STAFF REPORT

RE: Bel Aire Lakes Change Order No. 2

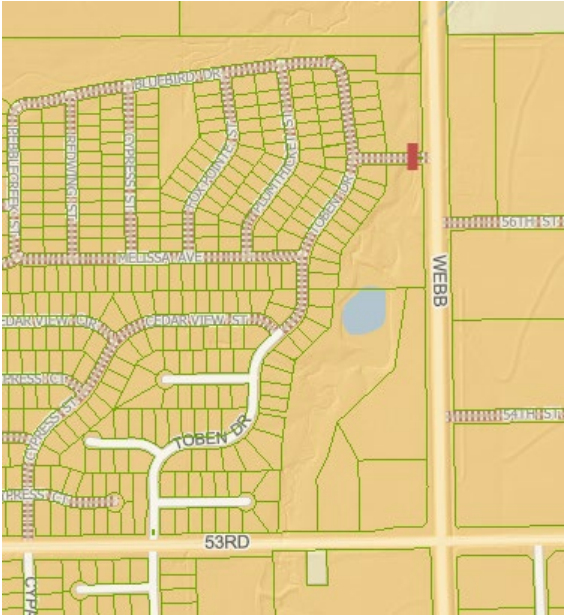
RCB Subgrade Foundation Work: The additional subgrade work authorized in December 2025 to shore up the stability of ground underneath the box culvert was not strong enough to support the box. Additionally, there is considerably more water entering the excavation than anticipated. The project team met on February 5th to discuss the current situation and receive guidance for how to proceed. PEC's geotech team was present at the meeting and it was generally agreed to by all present to go back to PEC's original recommendation of over-excavating to a depth of 7' from the flowline of the box. This depth will expose the shale, which should provide a solid surface from which to build up from. A larger aggregate will be used in the lower portion of the excavation with smaller aggregate being used closer to the top of the excavation.

Decommission Existing Well: An abandoned brick well was found within a copse of trees on the west edge of the RCB excavation. The well is roughly 5' in diameter and when found, was covered with a sheet of plywood. Costs to abandon the well have been included in this change order. The cost to abandon the well has been provided as a Not To Exceed Price, depending on what is found within the
